SEALT Comments on Level 1 Screening Results

Provided to the Juneau-Douglas North Crossing PEL Study and Technical Advisory Committee 3/17/23 in response to the request for comments on the application of Level 1 screening detailed in the 3/2/23 Technical Memorandum on Level 1 Screening Results.

**City & Borough of Juneau
COMPREHENSIVE PLAN**

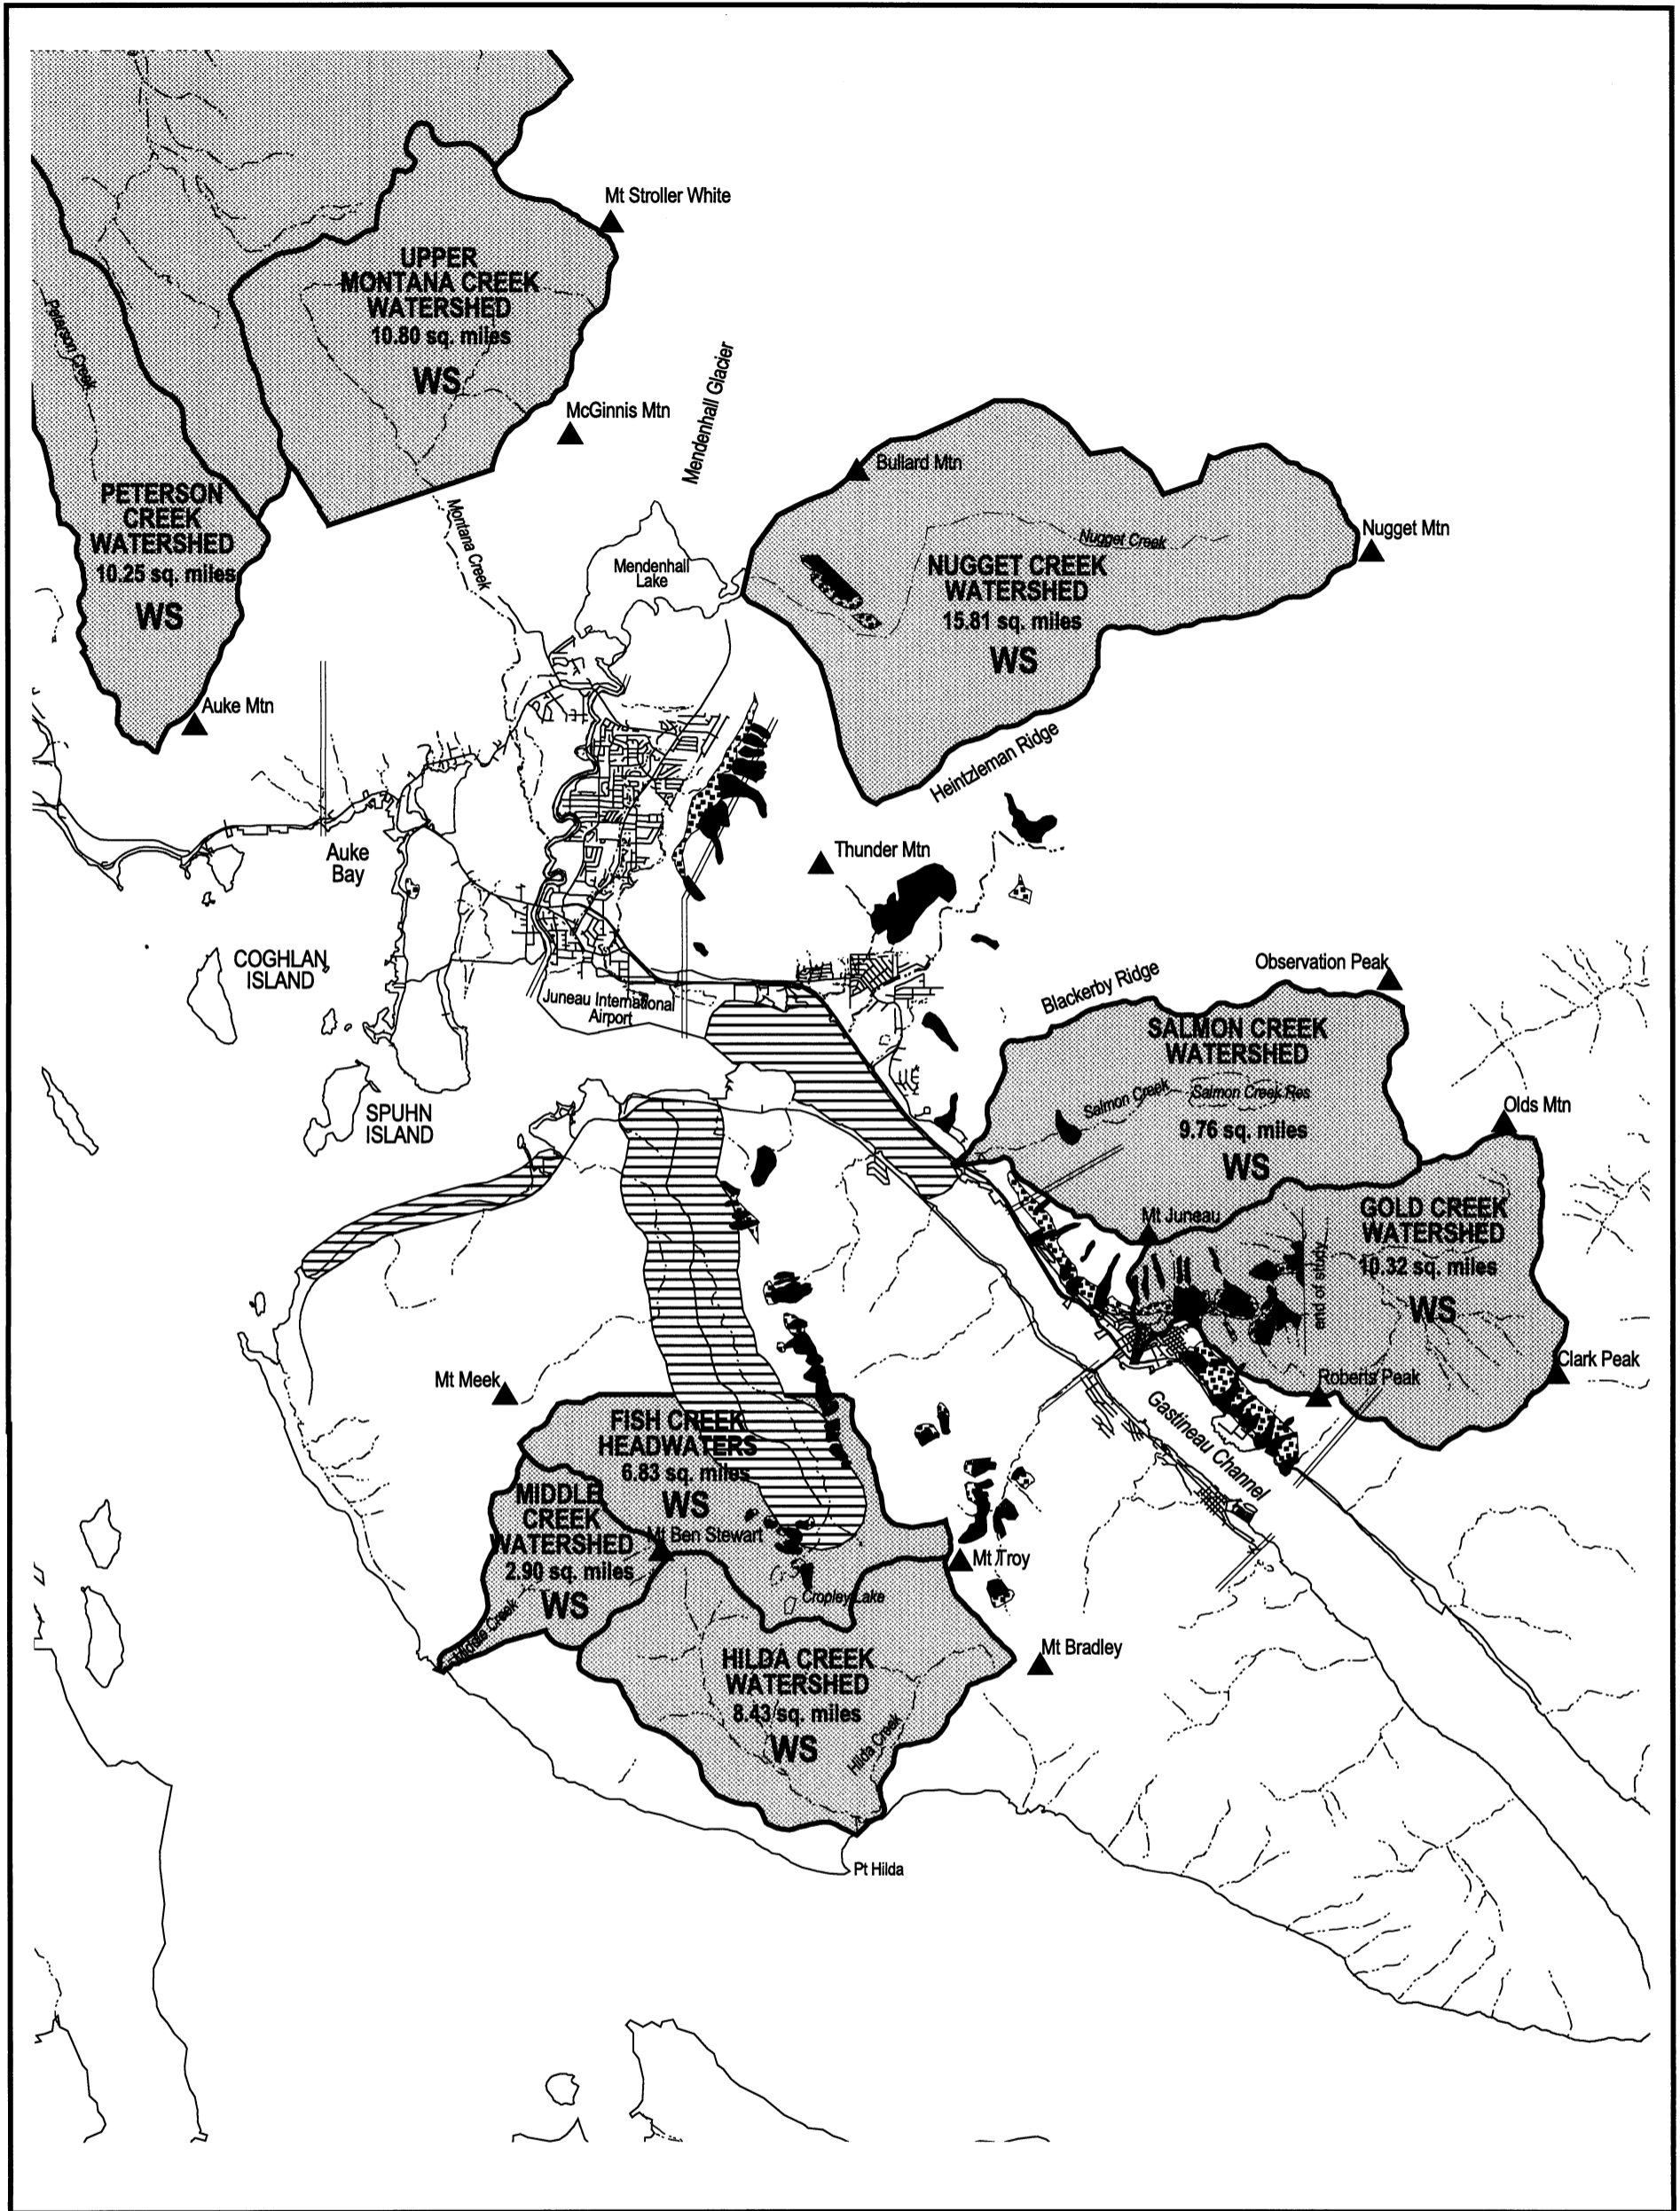
- a. The stretch of Gastineau Channel encompassing the Sunny Point and Vanderbilt Creek alternatives was designated in CBJ’s 2008 Comprehensive Plan as a scenic corridor/viewshed (see enclosed figure). The community of Juneau highly values this scenic viewshed and that recognition justifies evaluating this additional goal as “low” for the Sunny Point alternatives and the Vanderbilt alternative.

- 1) Table 2 (page 5) summarizes the results of screening each alternative for the Additional Goals. For the goal of maintaining the visual, cultural, and scenic identity of Juneau and Douglas Island, the West Sunny Point, East Sunny Point, and Vanderbilt alternatives are assigned a value of “medium.” These values should be changed to “low” for the following reasons:
